# Access Compliance Report

## Public Rights-of-Way

Intersection ID: 48713	Main Street: ROLLING_CREEK_CT	Cross Street: KILCULLEN_DR	Location: E
ADA ID: 5B1DD4443BD7	Ramp Type: PerpDiag	Initial Pass/Fail: Fail	Overall Compliance: No
Severity Score: 22.5			
Codes/Mitigation Info/Possible Solution		Field Measurements/Component Compliance

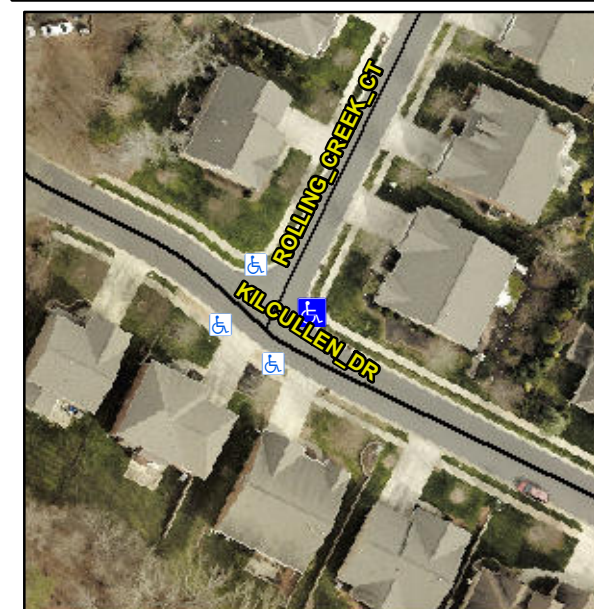
**Remove & Replace Curb Ramp With Two New Directional Ramps or Equivalent.**

**R304.5.1, R304.2.2, R304.5.3**

Compliance	Description	Data	Compliance	Description	Data
N/A	Ramp Length (in)	52.0	No	Ramp Slope (%)	10.0
No	Ramp Width (in)	46.0	No	Ramp XSlope (%)	3.3
N/A	Flare Type LT	N/A	N/A	Flare Type RT	N/A
N/A	Flare Slope LT (%)	N/A	N/A	Flare Slope RT (%)	N/A
N/A	Flare Traversable LT?	N/A	N/A	Flare Traversable RT?	N/A
N/A	Landing Length (in)	N/A	N/A	DWS Provided?	N/A
N/A	Landing Width (in)	N/A	N/A	DWS Contrast?	N/A
N/A	Landing Slope (%)	N/A	N/A	DWS Length (in)	N/A
N/A	Landing X Slope (%)	N/A	N/A	DWS Full Width?	N/A
N/A	Landing Curb? (Y/N)	N/A	N/A	DWS Offset (in)	N/A
N/A	Shared Landing?	N/A			
N/A	Gutter Ponding?	N/A	N/A	Gutter Slope (%)	N/A
N/A	Gutter Lip Ht (in)	N/A	N/A	Gutter X Slope (%)	N/A
N/A	Painted X Walk1?	No	N/A	Painted X Walk2?	No
	X Walk 1 Direction	To NW		X Walk 2 Direction	To SW
N/A	X Walk 1 Width (in)	N/A	N/A	X Walk 2 Width (in)	N/A
	X Walk 1 Slope (%)	2.5		X Walk 2 Slope (%)	0.9
	X Walk 1 X Slope (%)	0.7		X Walk 2 X Slope (%)	2.5
